## Avolites LTD Engineering Change Notice

ECN title	Titan Net Processor Impedance Matched Ethernet		
ECN Number	ECN-207		
Related Product(s)	All Titan Net Processors before TNP-0069		
Date / Author	27/06/2016	Grzegorz Ksiazka	
Reasons for ECN	Ethernet link quality can degrade due to poor signal integrity		
Parts required	Assembled TNPE 7332A snapoff board, four cable-ties 04-03-0039		
Tools required	PZ2 screwdriver, PZ1 screwdriver, 5.5 mm socket/nut driver, side cutters		
Estimated time	15 Minutes

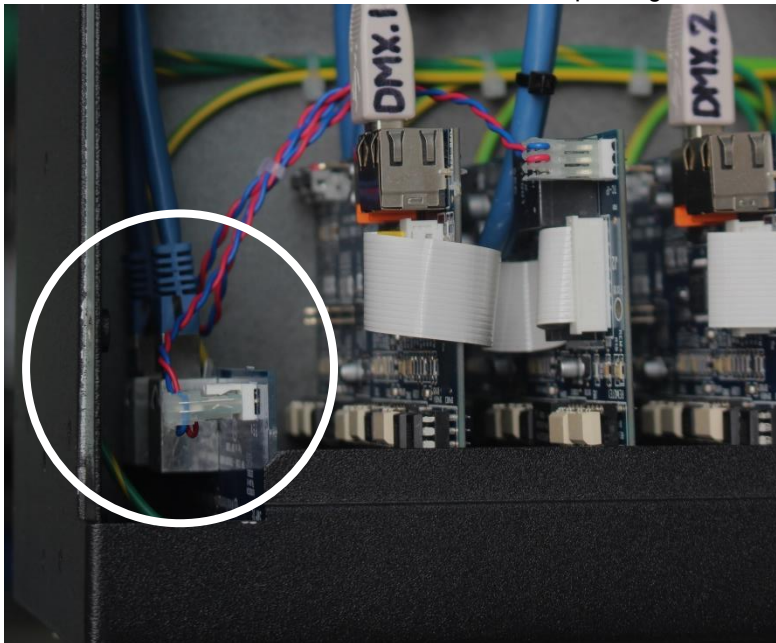
7. Run the earth wire on the bottom of the shell along the lance bridges with the other earth looms. Put crimp over the earth stud and refit the M3 nut, ensuring all other earth wires are in place, and in contact with one another.

Cable-tie the earth loom to the lance bridges using four cable-ties
